Environmental Management Disposal Facility SITE SELECTION

Environmental Management Disposal Facility Design

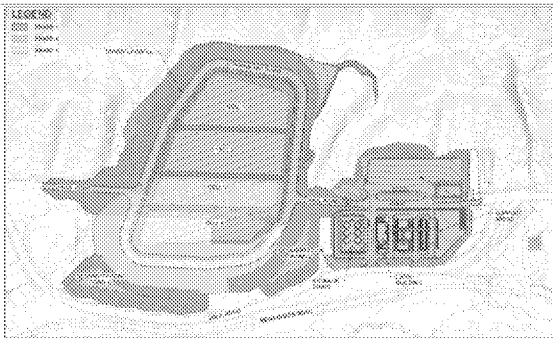
Commented [LE5]: Should we add arrows to represent groundwater/surface water flow away from the EMDF?

EMDF Liner System

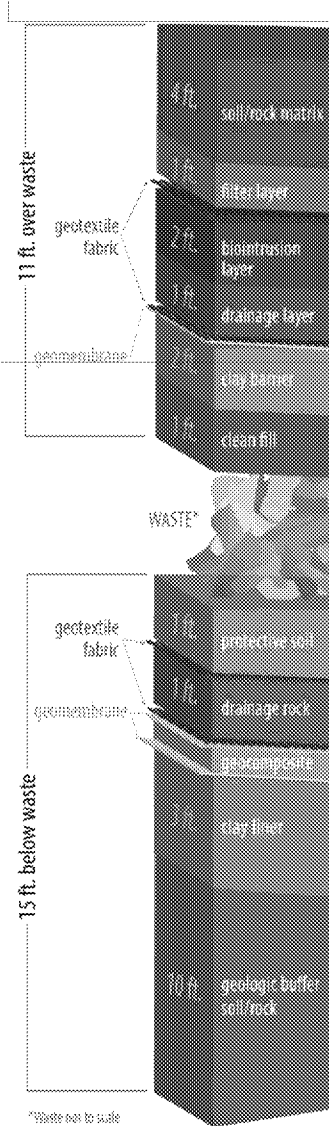
Commented [LE7]: Can a rough estimate of the thickness of waste be included on this graphic?

Commented [LE6]: The text on this image needs to be bigger for the reader to more easily see. The LWTs needs to be spelled out and explained somewhere in the fact sheet.
